PROVIDENCE PARK, P.O.B. WEST SUBDIVISION,
RESUBDIVISION OF LOT 1, RESUBDIVISION OF AND
ADDITION TO LOT 1

APPLICATION NUMBER 29 DATE March 6, 2008
APPLICANT Providence Park, P.O.B. West Subdivision, Resubdivision of
Lot 1, Resubdivision of and Addition to Lot 1
REQUEST Subdivision

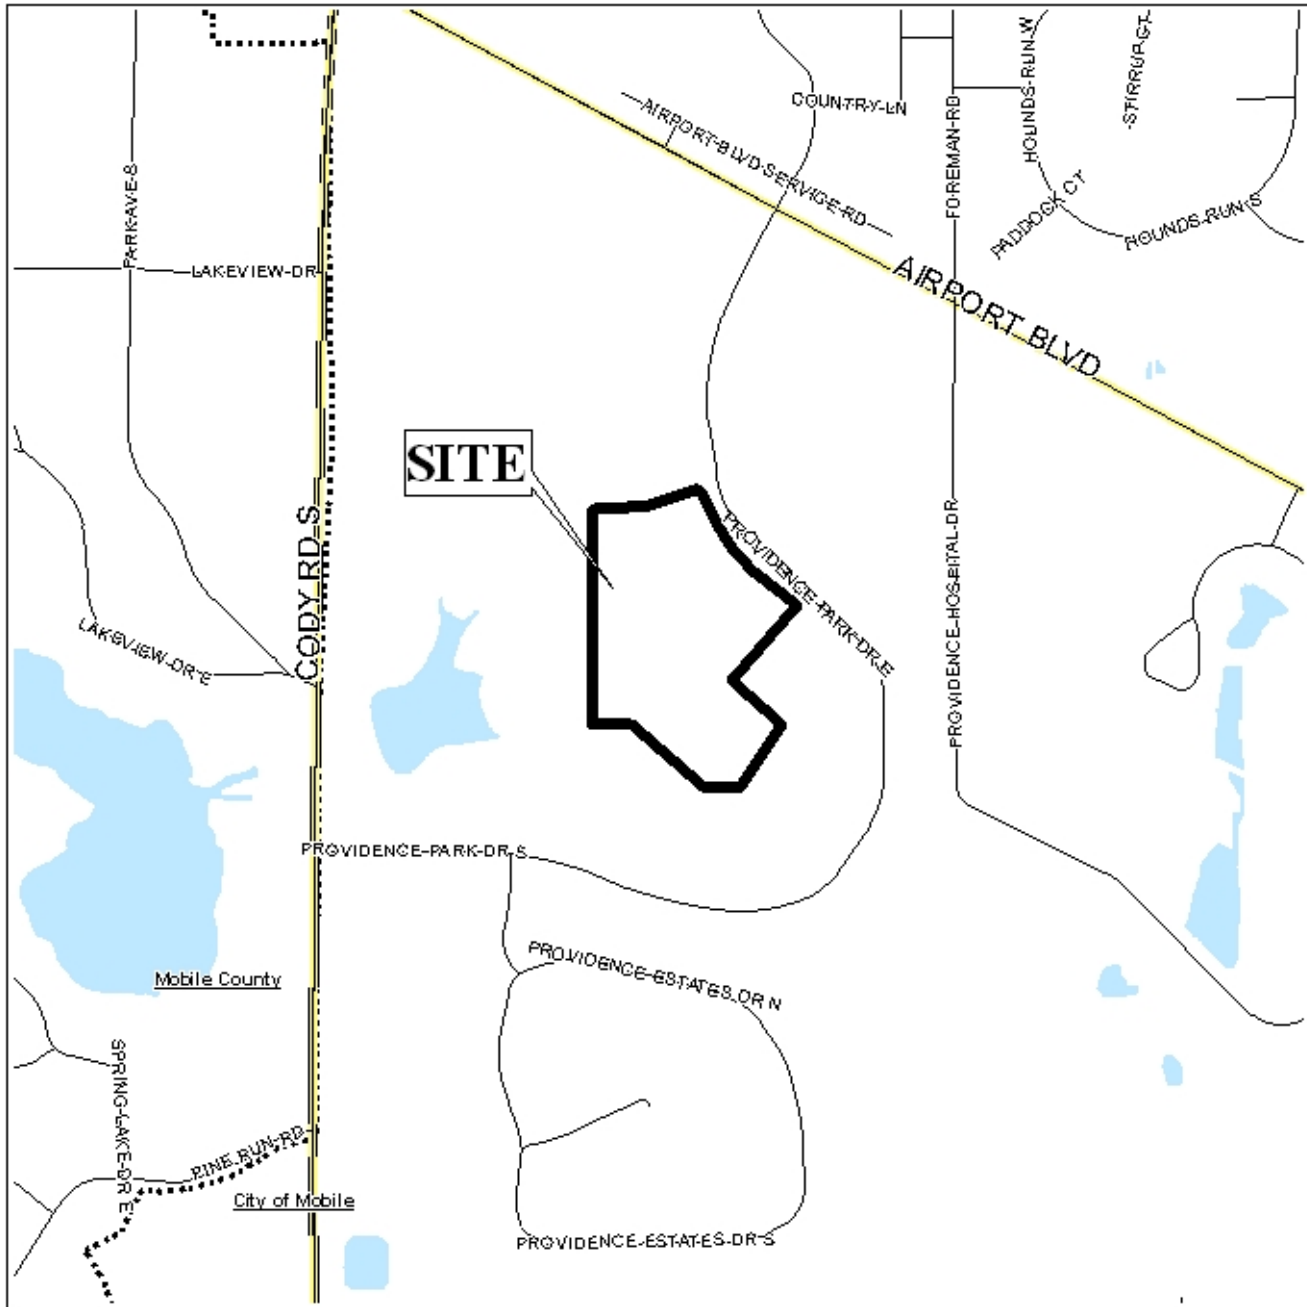
The plat illustrates the proposed 11.6 acre \pm , 11 lot subdivision which is located on the Northeast corner of Cody Road South and Providence Park Drive South, extending to the West side of Providence Park Drive East (private street), 890' + South of Airport Boulevard, and is in Council District 6. The applicant states that the subdivision is served by both public water and sanitary sewer.

The purpose of this application is to subdivide one lot and a portion of a parcel into eleven (11) lots. The site fronts onto an existing private street and a proposed private street, and includes the construction of a private cul-de-sac. As the site, or at least a portion of it, is part of a Planned Unit Development (PUD), an application to amend the existing PUD should have been included.

Based on the preceding, the application is recommended for Holdover until the April 3rd meeting so that the following can occur:

- 1) Submission of an application by March 17th to amend the existing Planned Unit Development, to allow the PUD to be considered at the April 17th meeting.
